Item Name: Quick Release Heli-Utility-Basket™ Long, HD Lid, Spacepod™/Squirrel Cheek Comp.

DART SERVICE INSTRUCTION

TO AMEND INSTALLATION INSTRUCTIONS D350-607-3 Rev.D,
INSTALLATION INSTRUCTIONS D350-607-4 Rev. C AND
INSTRUCTIONS FOR CONTINUED AIRWORTHINESS ICA-D350-607 REV. 6
REF TCCA STC: SH94-14
REF FAA STC: SR00213NY
REF EASA STC: EASA.10016996
REF BRAZILIAN STC: 2007S03-03/-04/-05/-06

FIGURE 1: INSTALLATION OF D4775-041 FWD STRUT

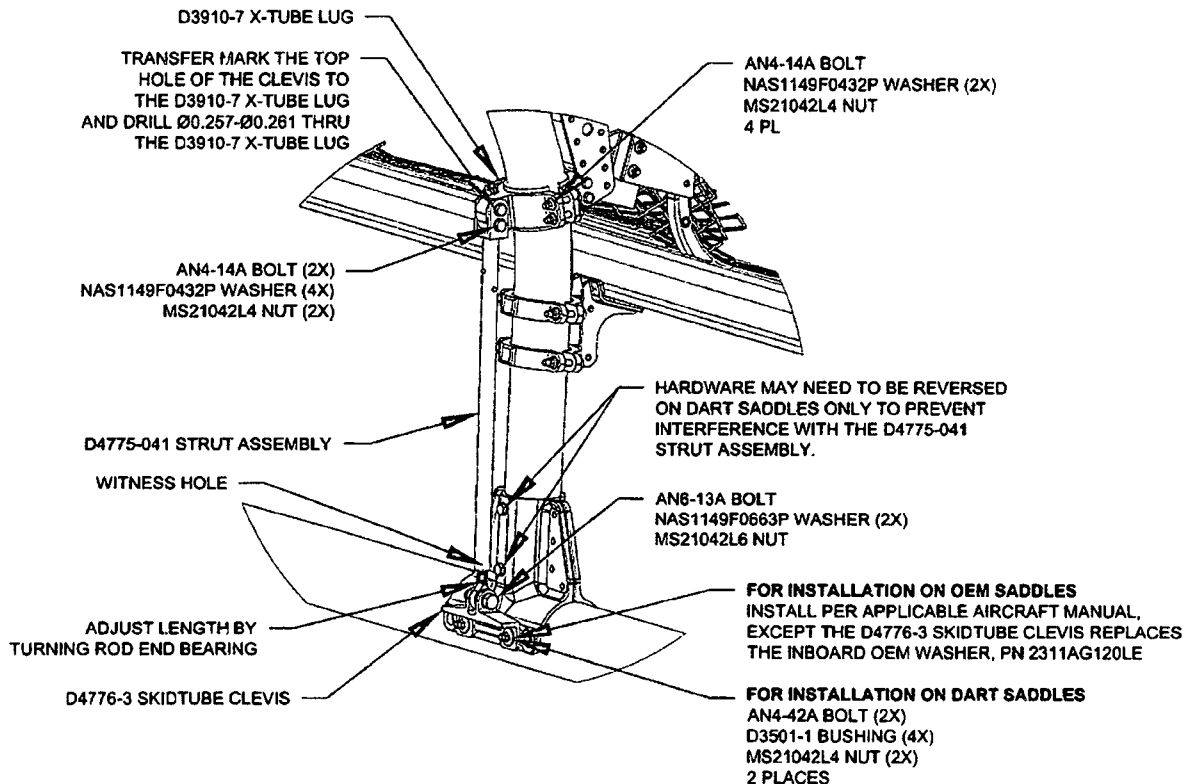
3.1 Substitute the Forward Lower D3910-5 X-Tube Lug with the D3910-7 X-Tube Lug as shown in Figure 1.

3.2 Install the forward D4775-041 Strut Assembly. Transfer mark from the upper hole on the clevis of the D4775-041 Strut Assembly to the D3910-7 X-tube Lug and drill thru the lug $\varnothing 0.257$ - $\varnothing 0.261$ as shown in Figure 1. Touch up chemical conversion coating per MIL-DTL-5541. Check the witness holes located at the bottom end of the D4775-041 Strut Assemblies to ensure that the thread from the rod end extends past the witness hole.
Torque MS21042L4/-4 nuts to 50-70 in-lbs (5.7-7.9 N-m). Torque MS21042L6/-6 nuts to 160-190 in-lbs (18.1-21.5 N-m).
